| Model: Model S-F2 | | Date: 30-Jan-03 | No.: RH556001 |
| Subject: Service Manual Correction (Model S-F2) | | Prepared by: M. Mano | |

Please apply the following corrections to your Service Manuals.

DF Rear Cover

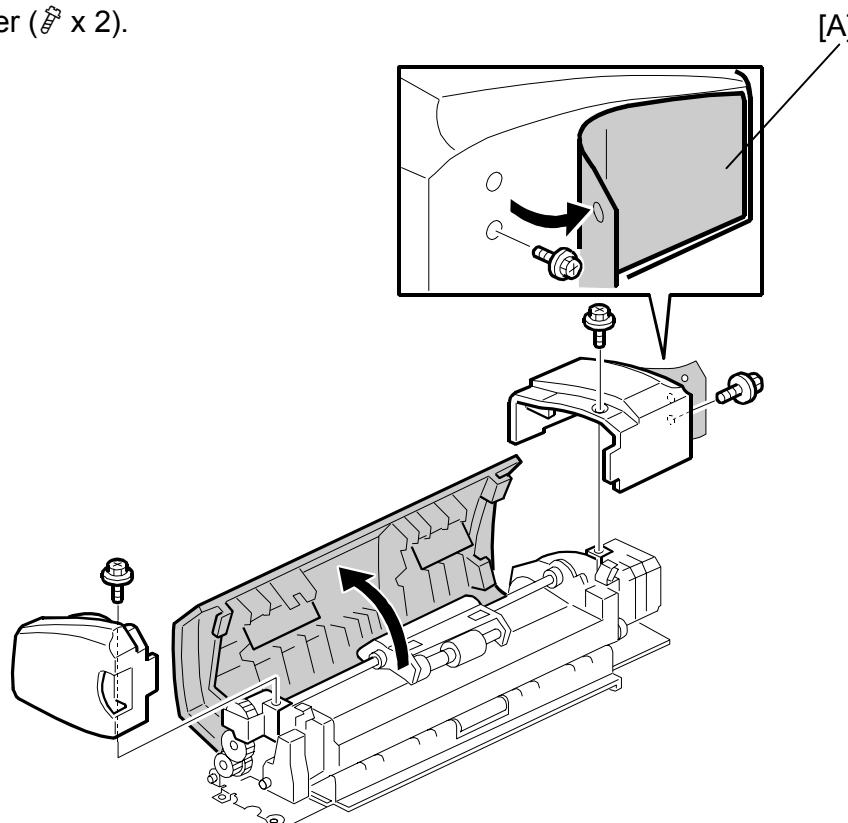
Please note the following procedures that should be used when servicing machines produced in January '03 in the field.

1. The current Service Manual procedures should be used for all machines from Feb '03 production onward.
2. The procedures are different only for Jan '03 units since these machines use an ADF Rear Cover Sheet (not Screw Cap), and a different ADF Rear Cover (see MB No. MH556008).

Sec. 3.4.5 DF COVERS, DF Rear Cover Replacement (Page 3-4)

1. Peel off the Mylar [A] as shown.
2. DF rear cover (🔧 x 2).

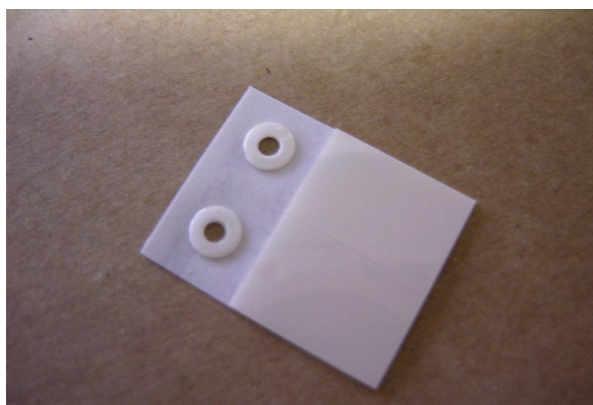
The stamp solenoid can get caught on the edge of the stamp cover opening, preventing the stamp cartridge from returning to home position and triggering an original jam.

The stamp cover opening is small enough so that when the solenoid is off-centered by a wide margin, it can catch on the edge of the opening.

The opening in the stamp cover has been increased.

Applied from: March '03 production.

Stamp Spacer (H5579900) Attachment Procedure

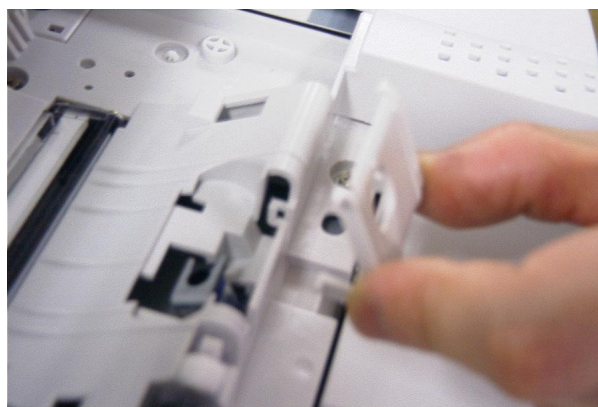
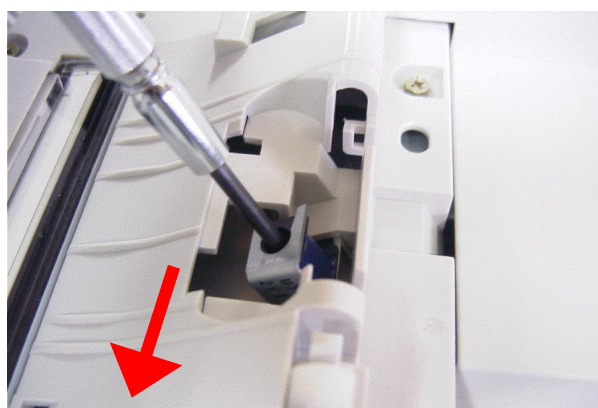
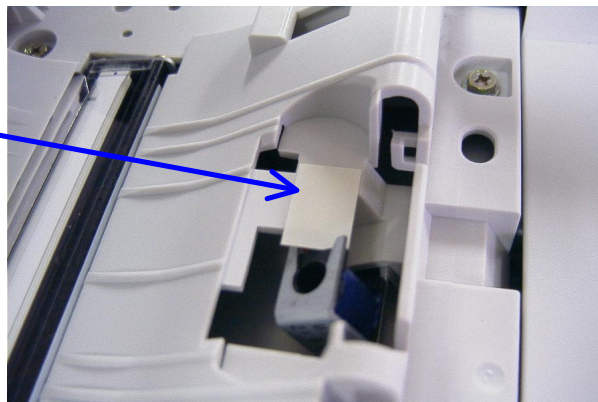
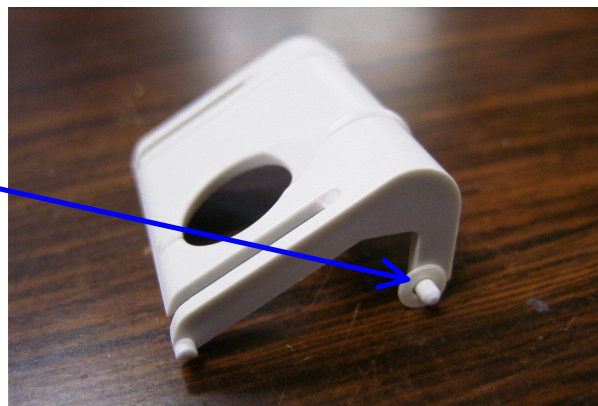
Attach a Stamp Spacer (P/N **H5579900**, qty. 2) if the symptom is reported, or as an extra preventative measure at stamp solenoid or stamp cover replacement.

1. Open the ADF unit.

2. Remove the stamp cover.

3. Remove the stamp cartridge, then slide the solenoid to the front as far as it will go.
(However, if it does not move easily, please leave it as is.)

4. Attach the Stamp Spacer so that it keeps the solenoid in the position set in Step 3 (preventing it from sliding to the rear).

5. Attach the spacer mini-shaft to the side of the stamp cover shown (this side only).

6. Reattach the stamp cartridge and stamp cover, then close the ADF unit.

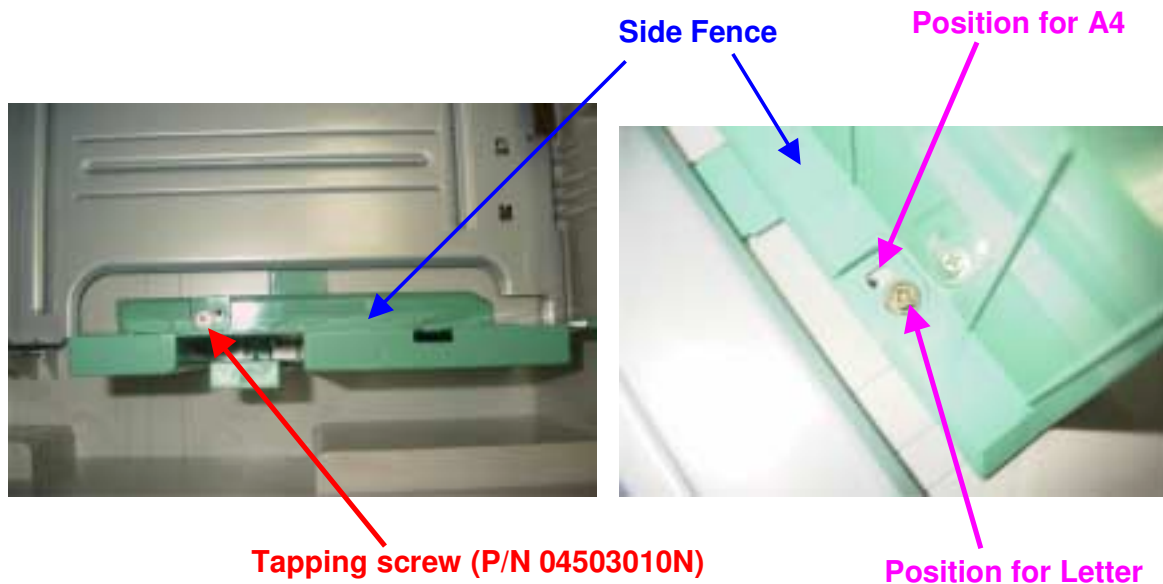
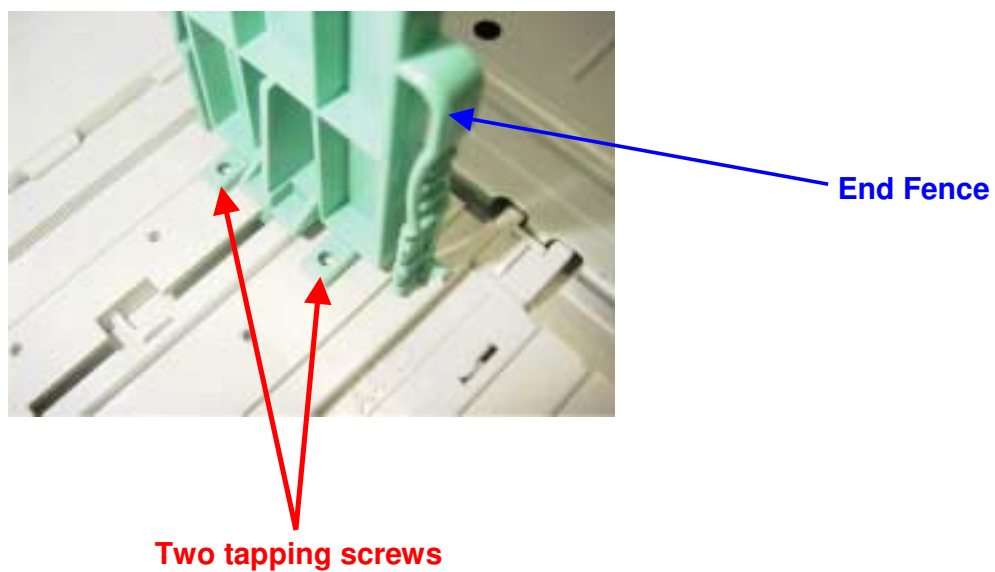
The side fence can shift inward when the operator loads the paper incorrectly (e.g. not fanning the stack, not placing it in the tray gently), which can then tighten the fence's hold on the paper and make it difficult to feed.

A tapping screw (P/N 04503010N) will be packed together with the optional paper tray unit (B421) for securing the side fence in place at installation.
 Applied from: June 2004 unit production.

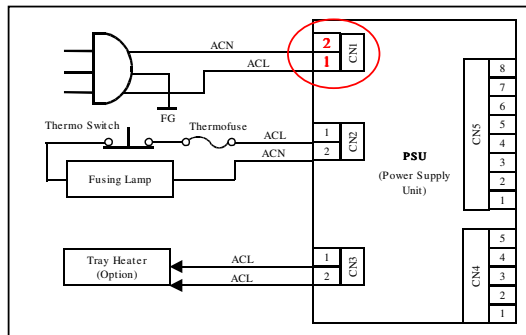
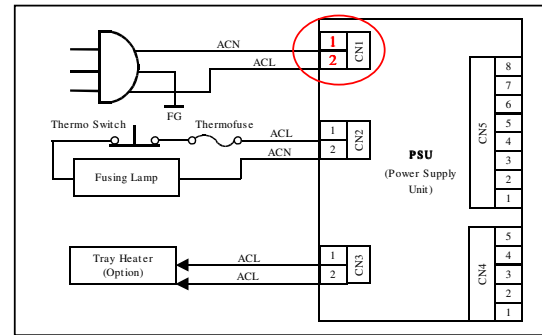
Even though the hot and neutral wires are reversed, **this will not cause any kind of safety issue**. The machine is completely safe when the operator uses the machine, and when technicians do maintenance.

The P-to-P diagram for machines produced up until October is different from the P-to-P diagram for machines produced from November. Please keep two separate P-to-P diagrams, as shown below:

- P-to-P for machines **up until October**: Should show the hot and neutral lines in the **wrong** position (reversed).
- P-to-P for machines **from November**: Should show the hot and neutral lines in the **correct** position.

Up Until October 2004:
Wrong Position (reversed wiring)

From November 2004:
Correct Position (original wiring)

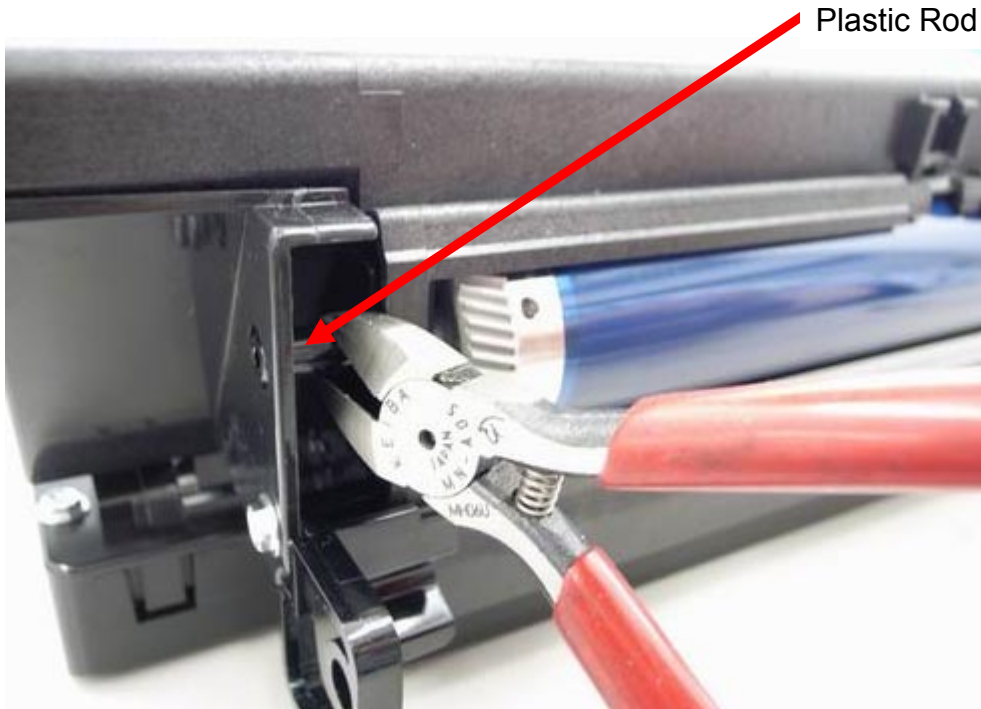
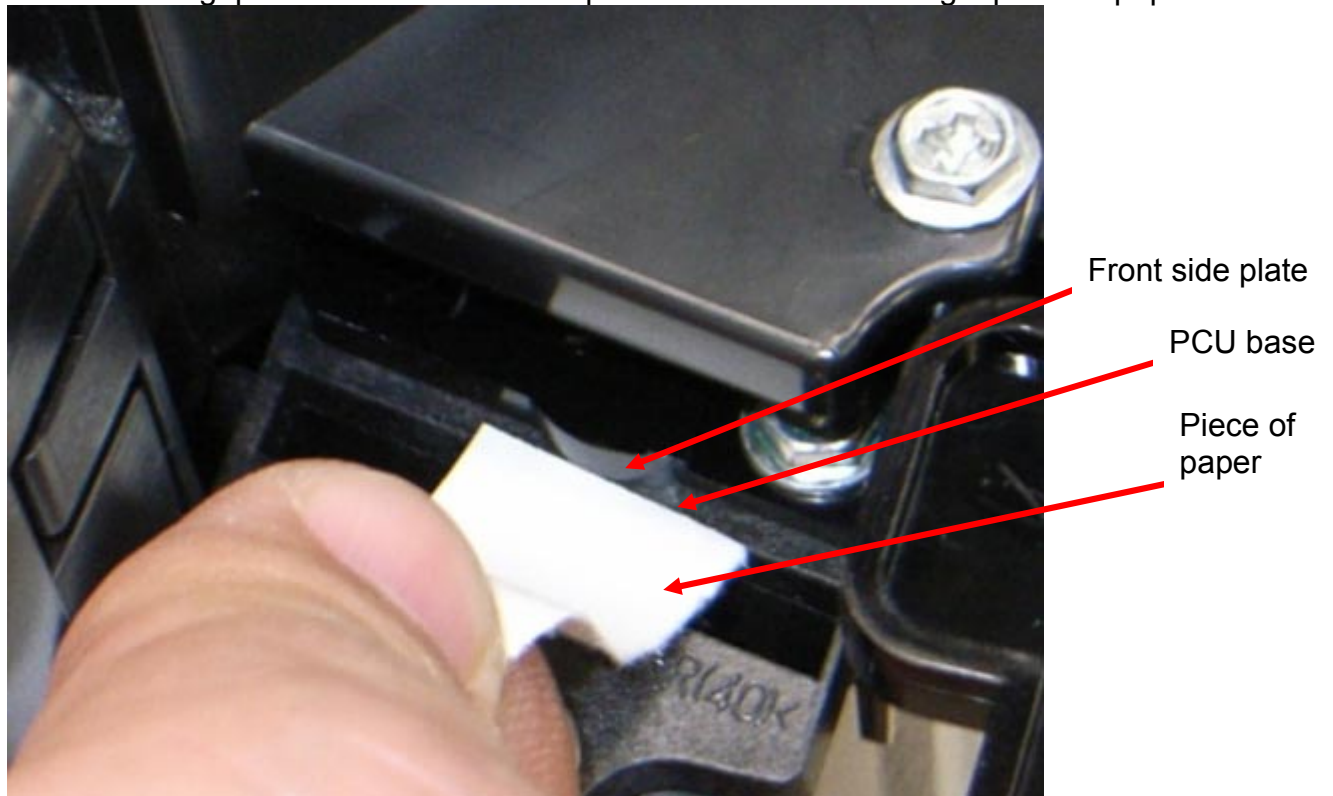
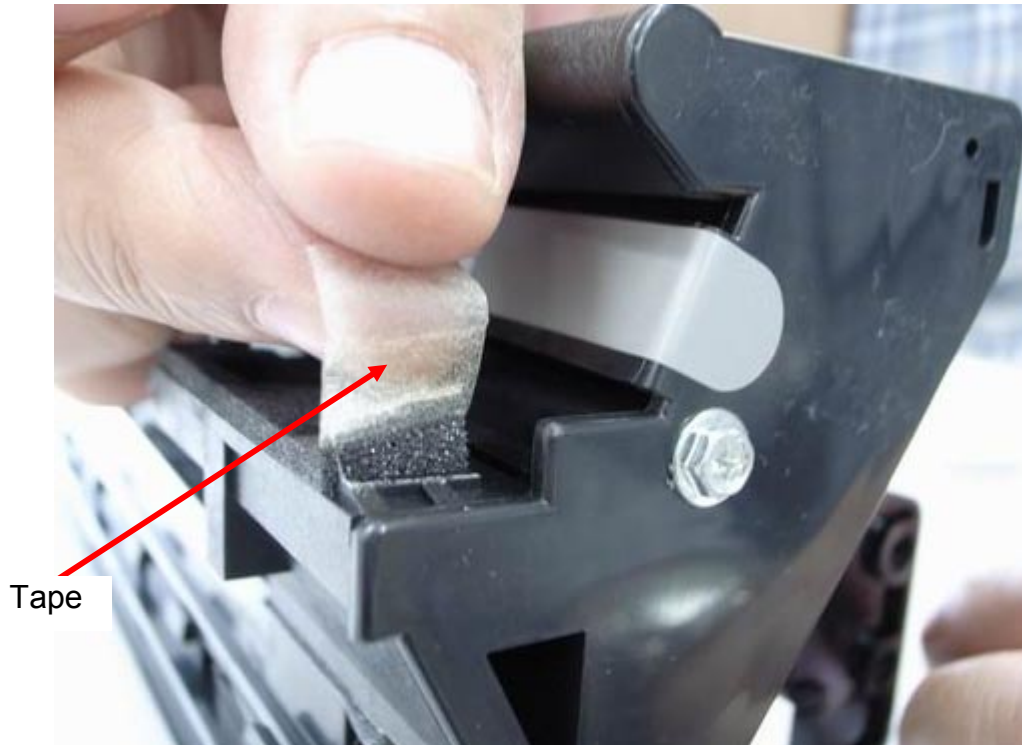
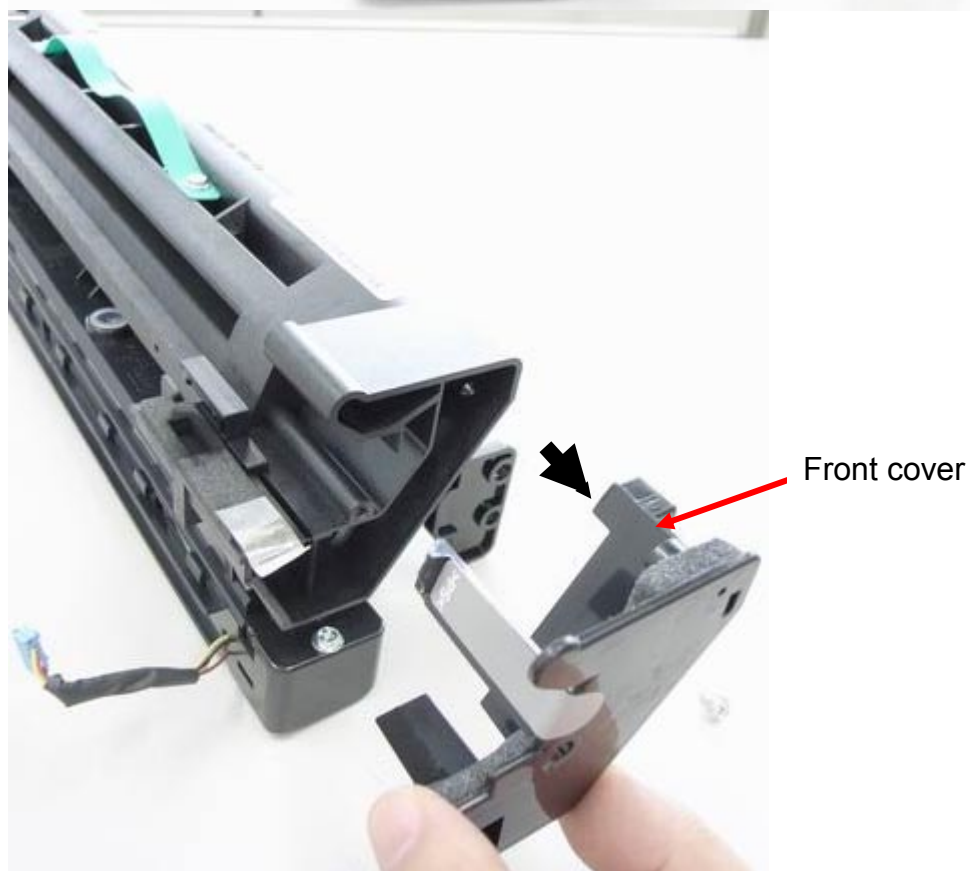
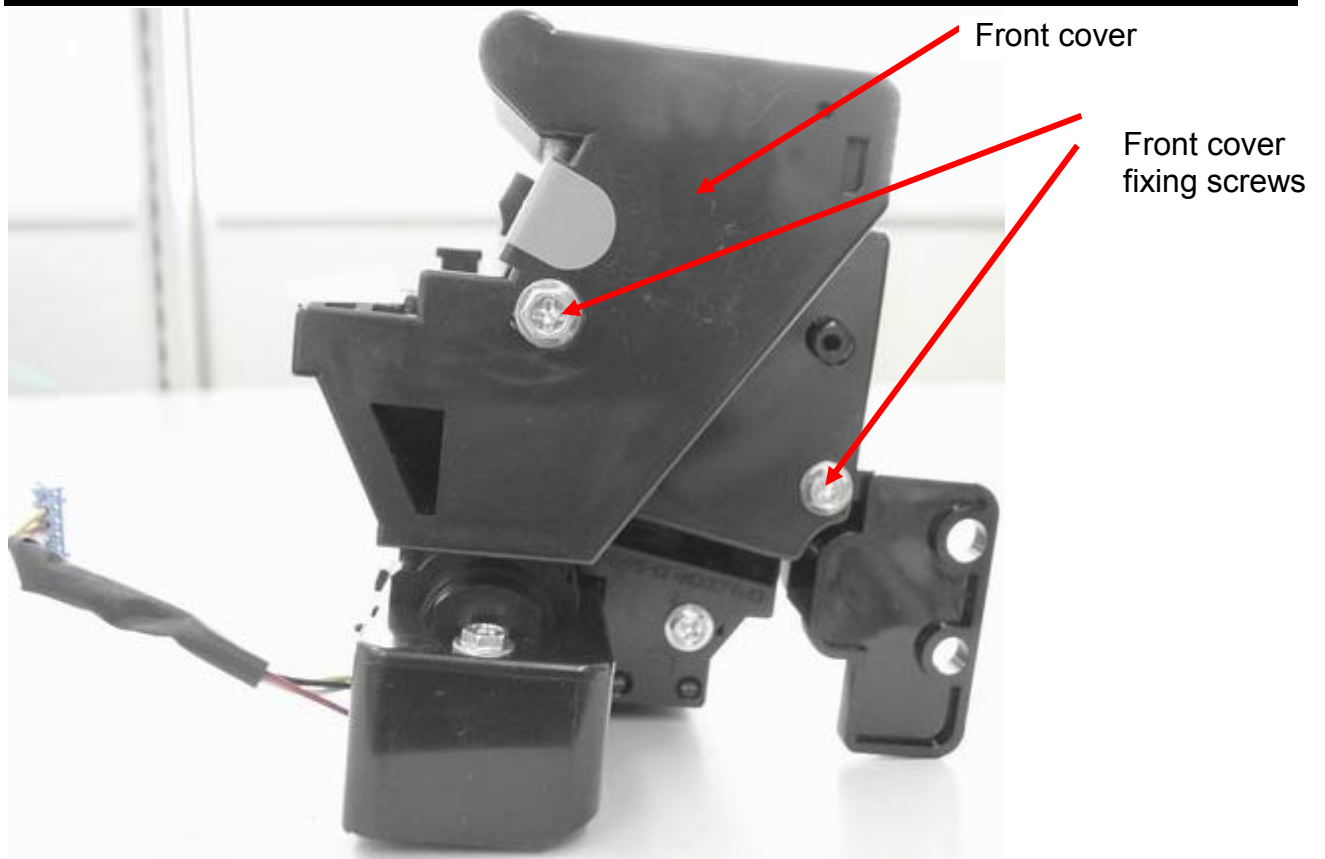
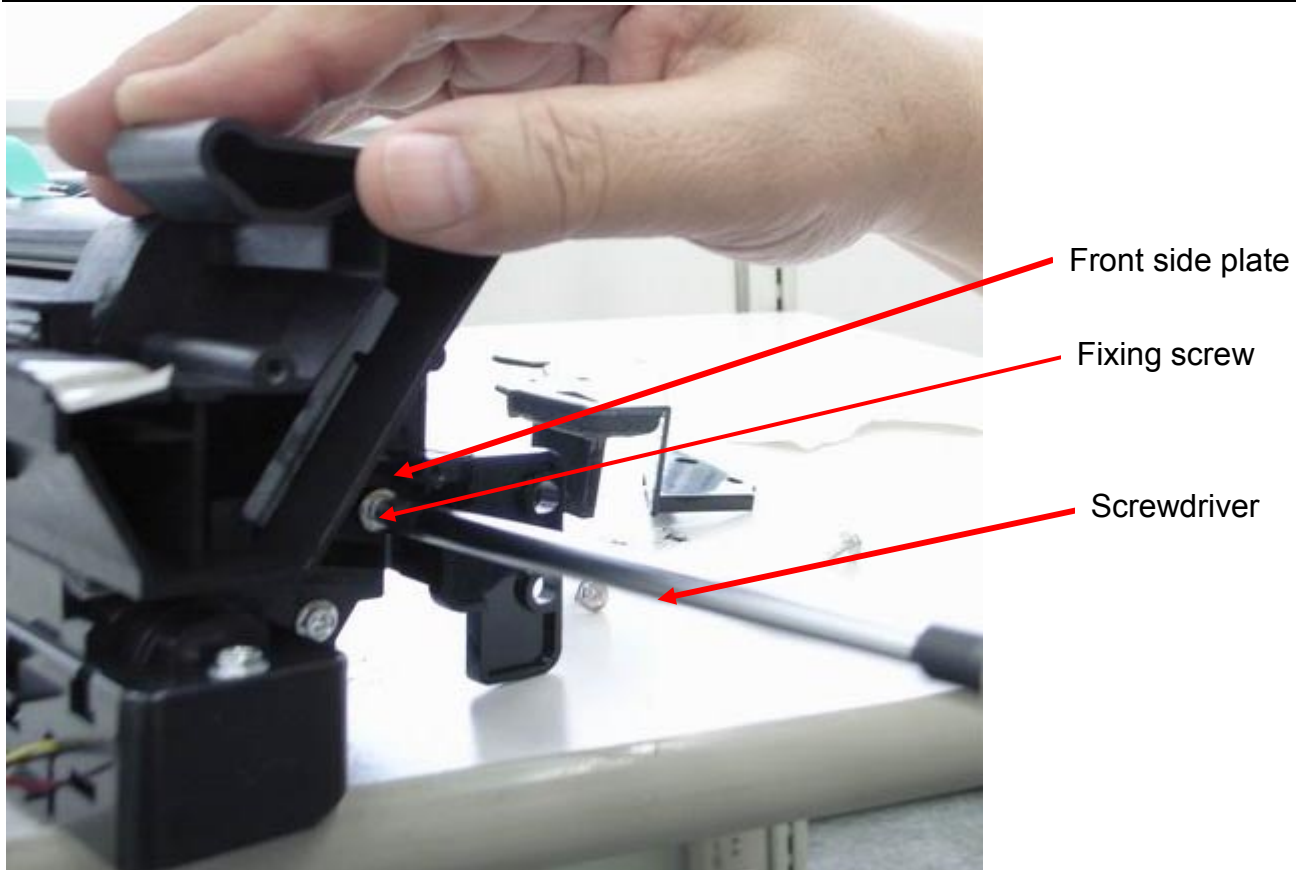
The PCU assembly process was modified as follows:

- A step was added to ensure that there is no gap between the front side plate and PCU base.
- The plastic rod on the PCU front side plate will be removed (cut).

Note: As mentioned below, there is no side effect created by removing this rod from the PCU. This is true for both normal PCUs and affected PCUs.

1. Cut and remove the plastic rod using a pair of needle-nosed pliers.

2. Check the gap between the front side plate and PCU base using a piece of paper.

If you can insert the piece of paper into the gap in Step 2, continue with this procedure.

3. Remove the tape and front cover of the PCU (2 screws).

4. Loosen the fixing screw for the front side plate.
 5. Press the front side plate in the direction of the white arrow (**see the photo on the next page**).
- Note:** This is to eliminate the gap between the front side plate and the PCU base.
